RECEIPT DATE: 3/1/17 **ONSITE SEWAGE DISPOSAL SYSTEM**

APPROVAL DATE: 3/15/17 **PERMIT: CONSTRUCTION**

**RE: BAT Plan Review
 7077 Mink Hollow Road
 Danner Property**

SITE PLAN FOR BAT INSTALLATION
7077 E. MINK HOLLOW ROAD
TAX MAP 40, PARCEL 357
DANNER PROPERTY
5th ELECTION DISTRICT
HOWARD COUNTY, MARYLAND

**2,000 GALLON SEPTIC TANK
2-Compartment**

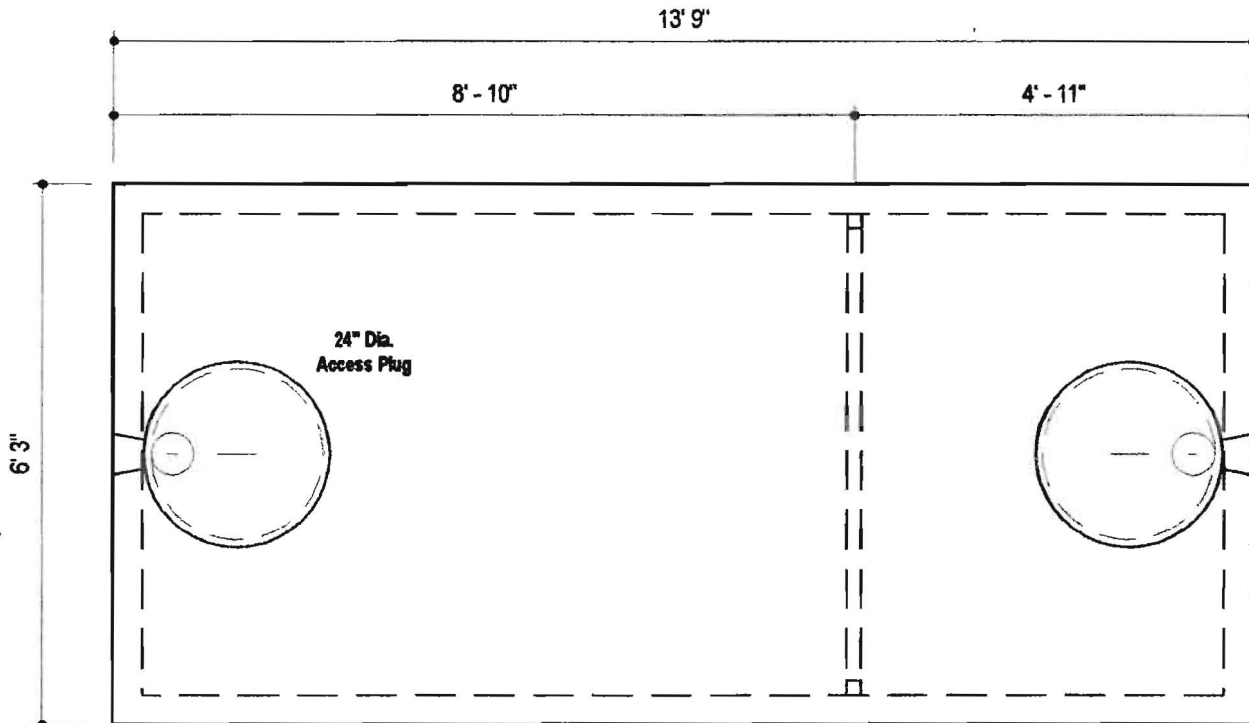
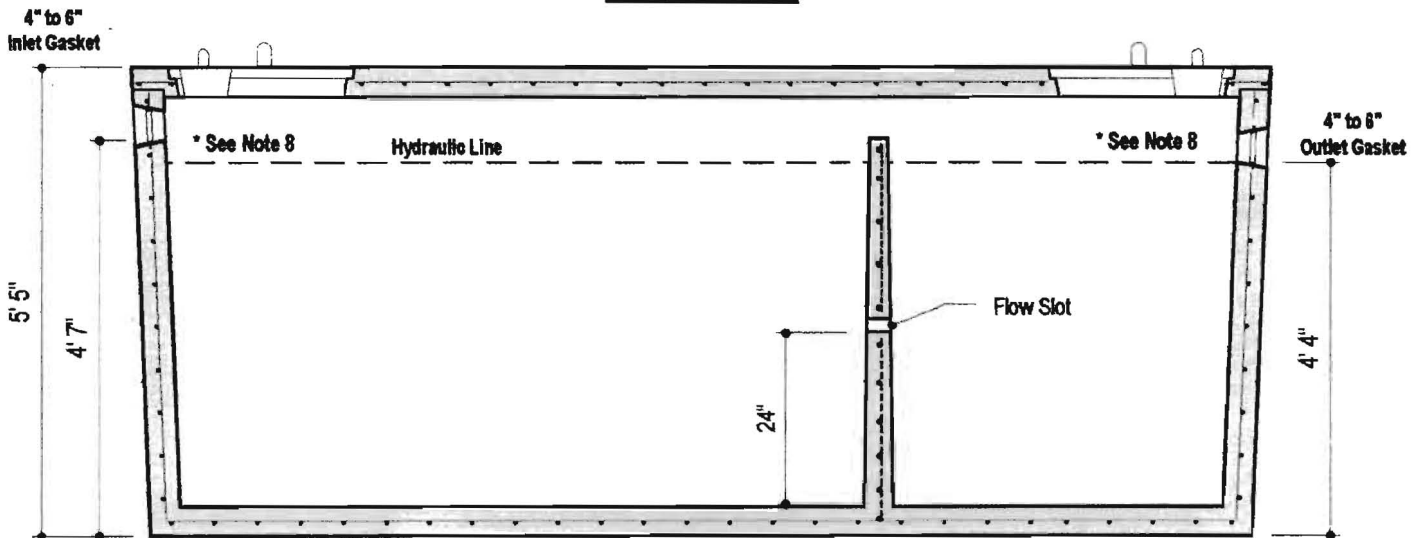
This tank does not contain the slot in the middle wall as described in my email. Please contact the company and forward the spec with the appropriate details.

This tank has two 4 inch outlets. It should have one outlet. In addition, the tank is required to have a middle wall with a minimum 2 inch slot located in the center of the liquid length and extend 4 feet in length. I noticed a "plot date" of 5/31/96. Perhaps your supplier can provide an updated version of their 2000 gallon tank.

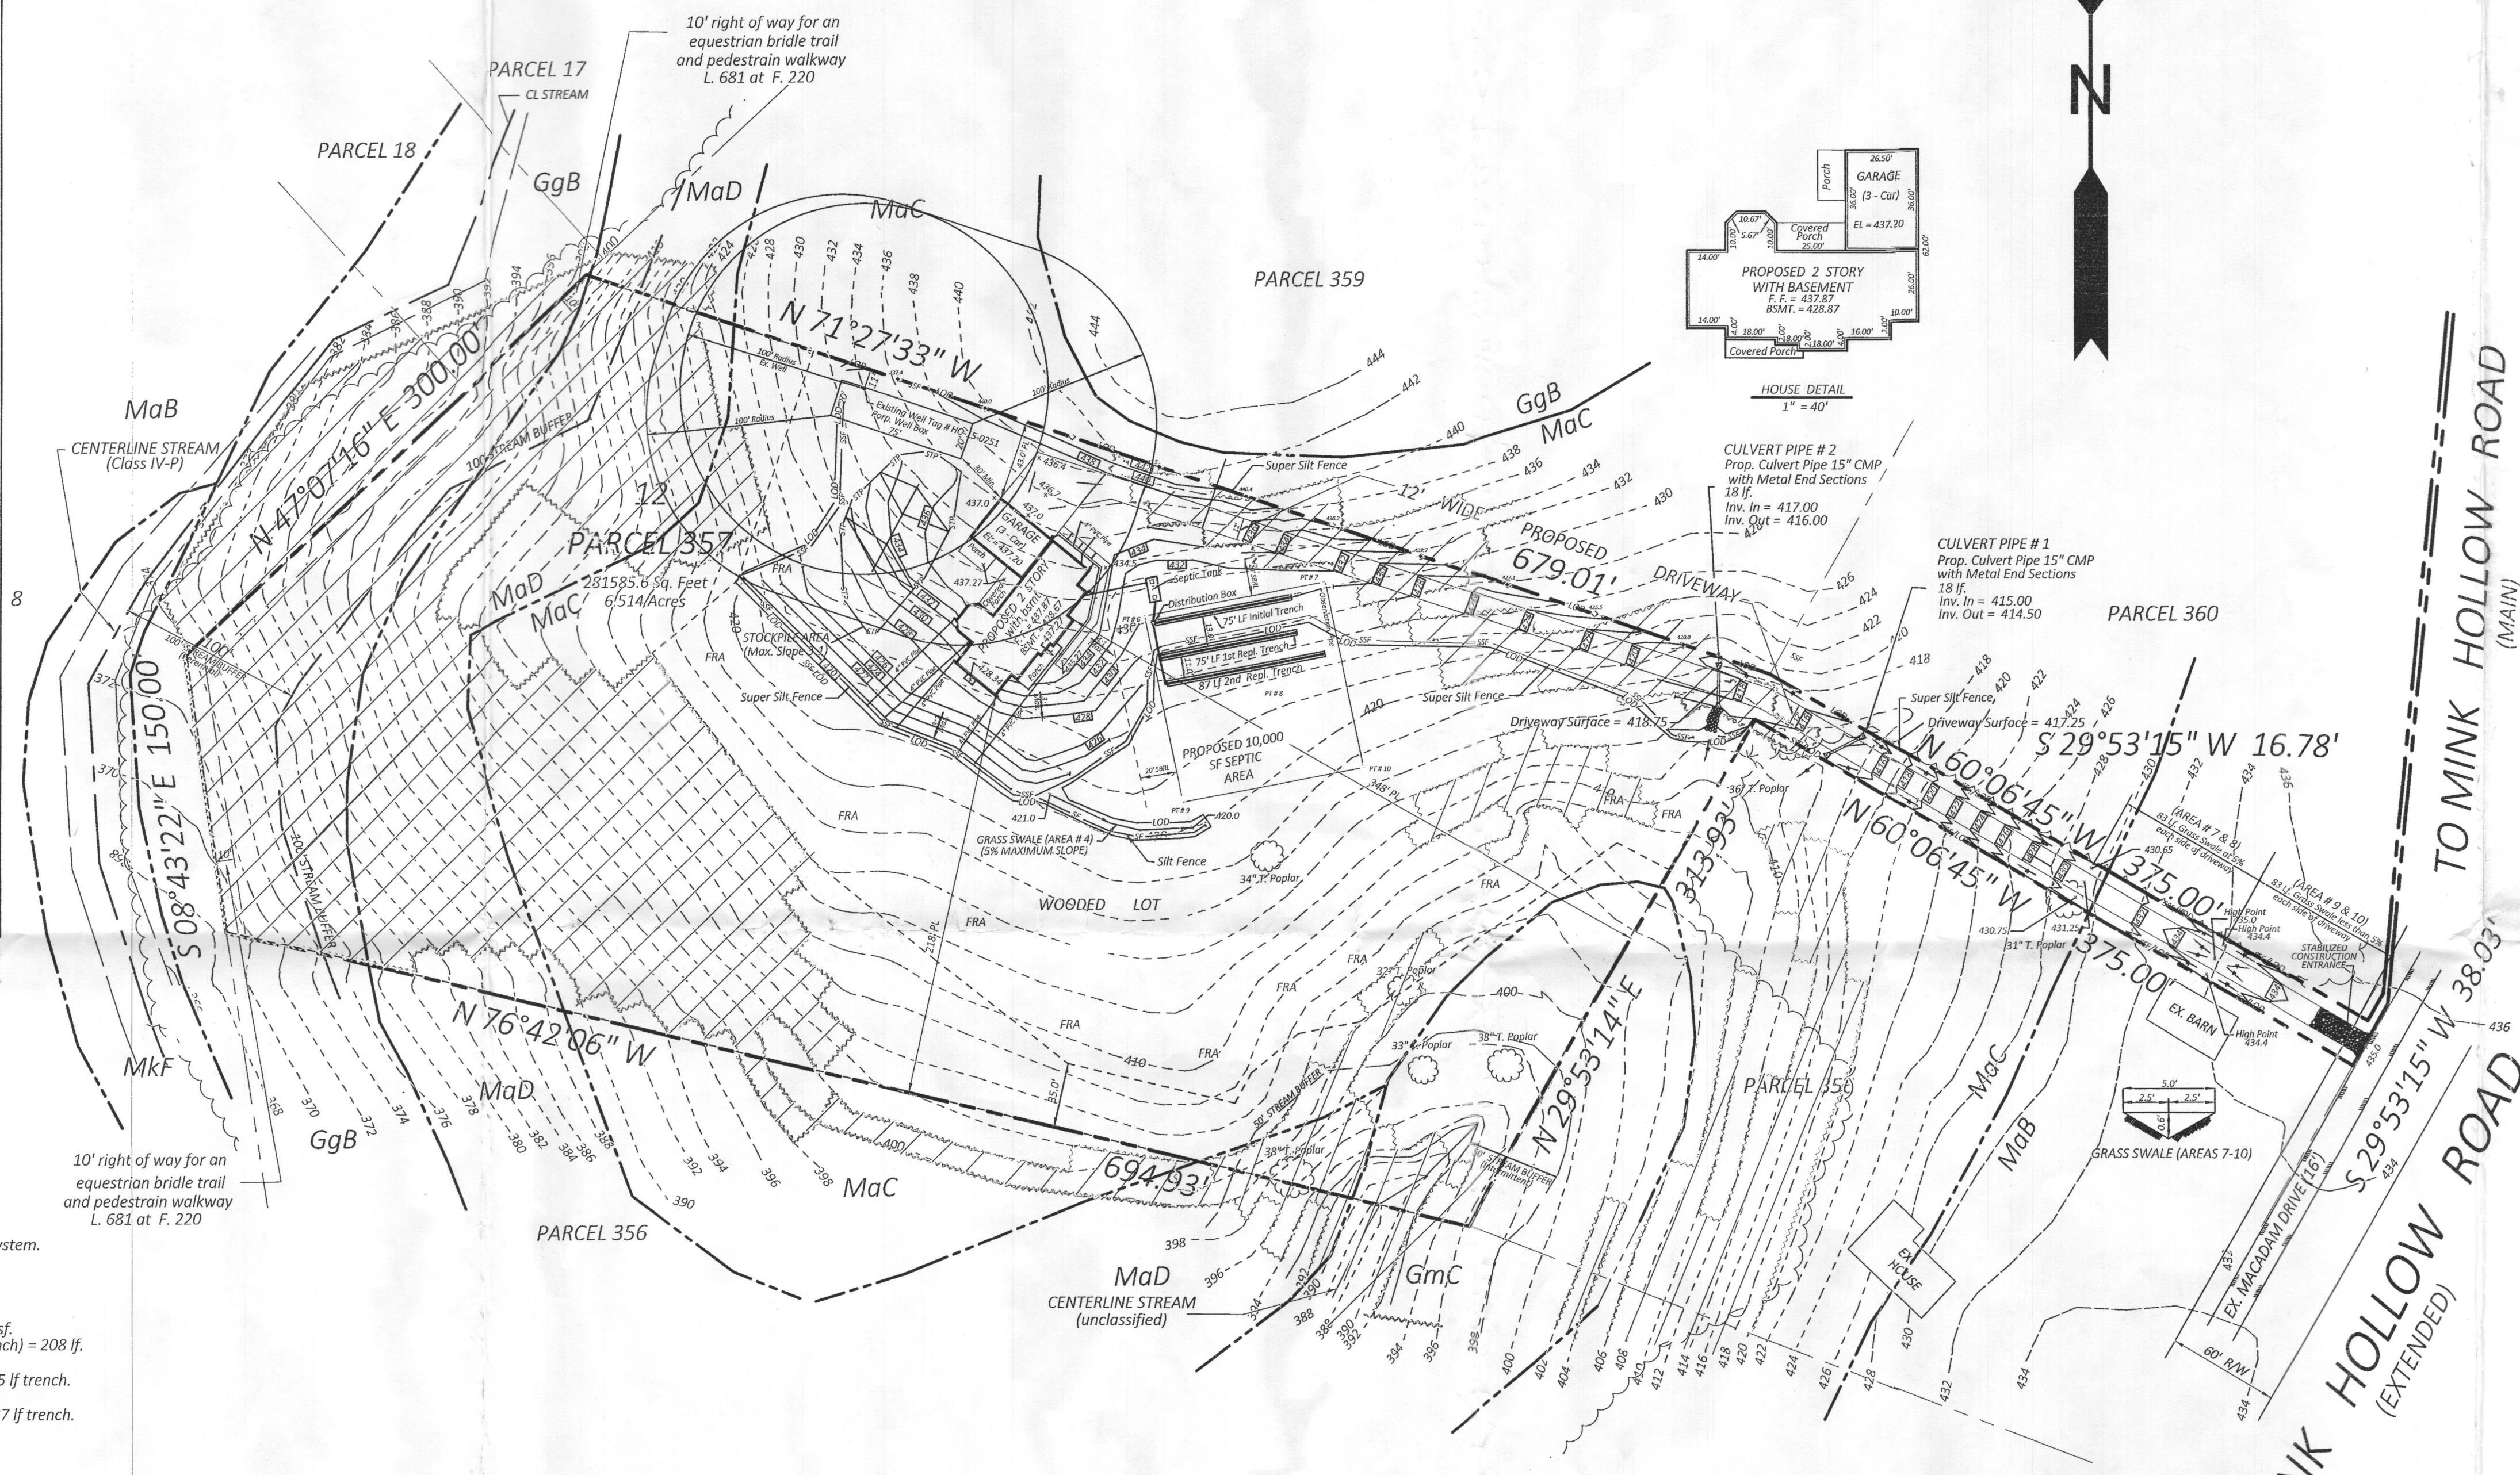
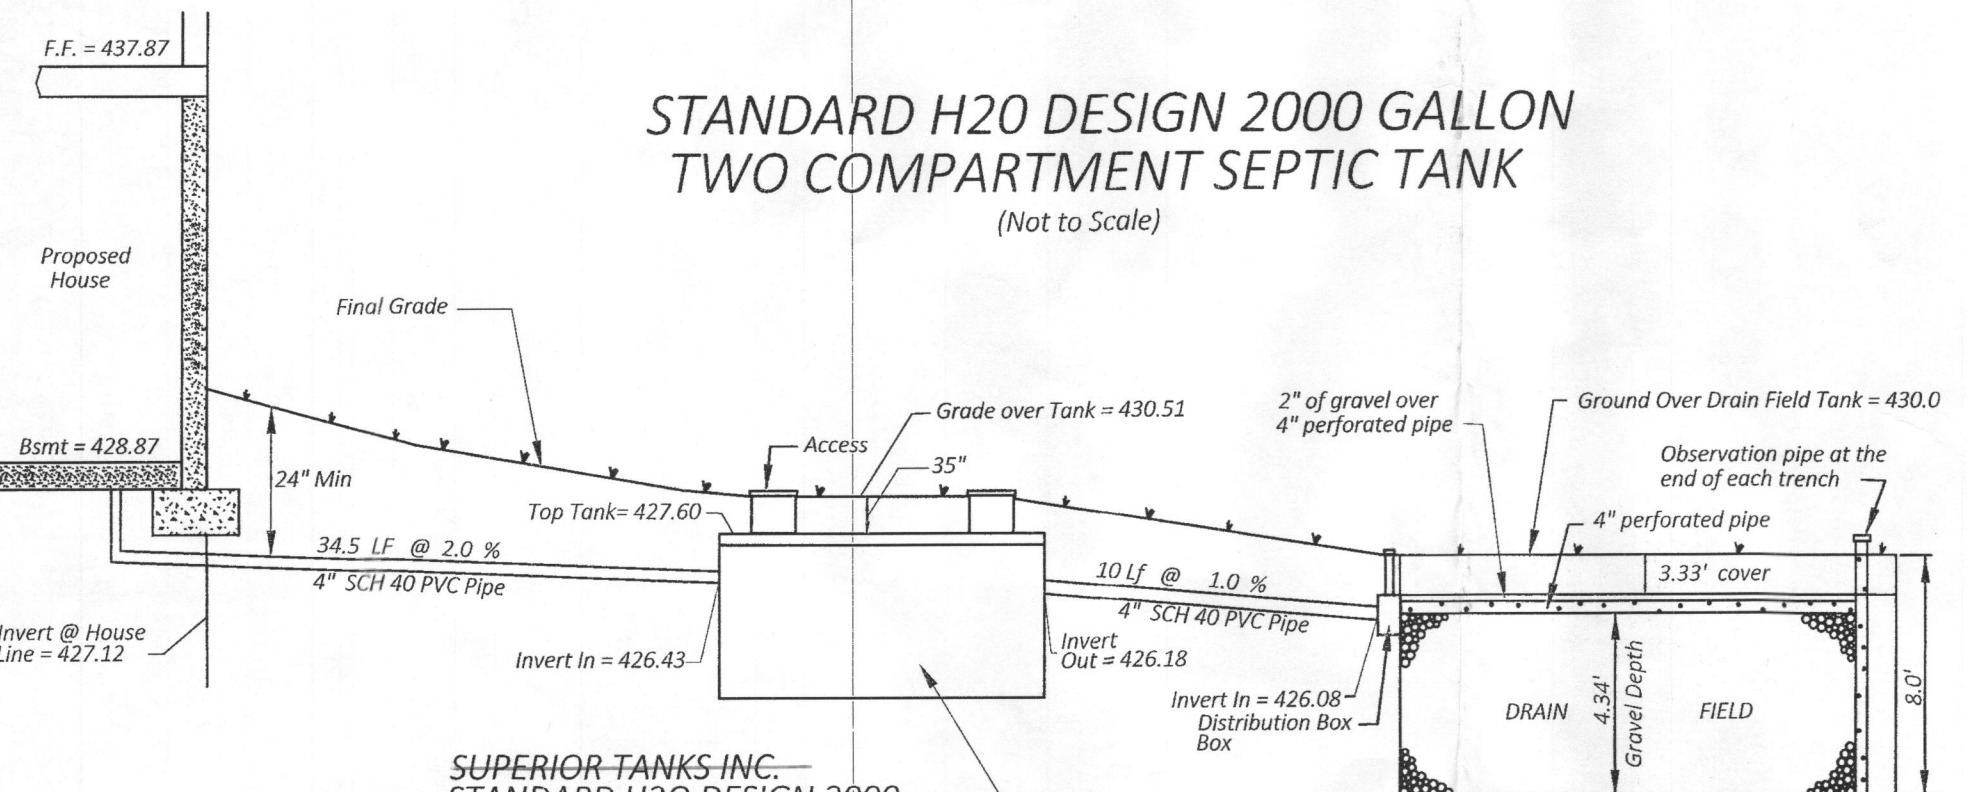
- 1.) Size system for 5 bedrooms (Per Owner).
- 2.) Replace 960LP (Not used in this county) with Norweco TNT 500 (up to 5 bedroom design flow)
- 3.) Show cross section and details of all BAT components
- 4.) Verify max depth on tank. Its stated 4 feet but it might be 3 feet.
- 5.) Septic Trench Info, Length of Trench = 167. Is this correct?
- 6.) Show distribution box

I just received the floor plans for the Danner property. By bedroom definition (see attachment), the floor plans show 6 bedrooms. The BAT Plan is only sized for 4 bedrooms. Please revise the BAT Plan accordingly before submitting to the H.D. for review.

DATE	REVISION
Aug. 6, 2016	HD Comments
Feb. 13, 2017	Revise BAT system to conventional gravity flow system
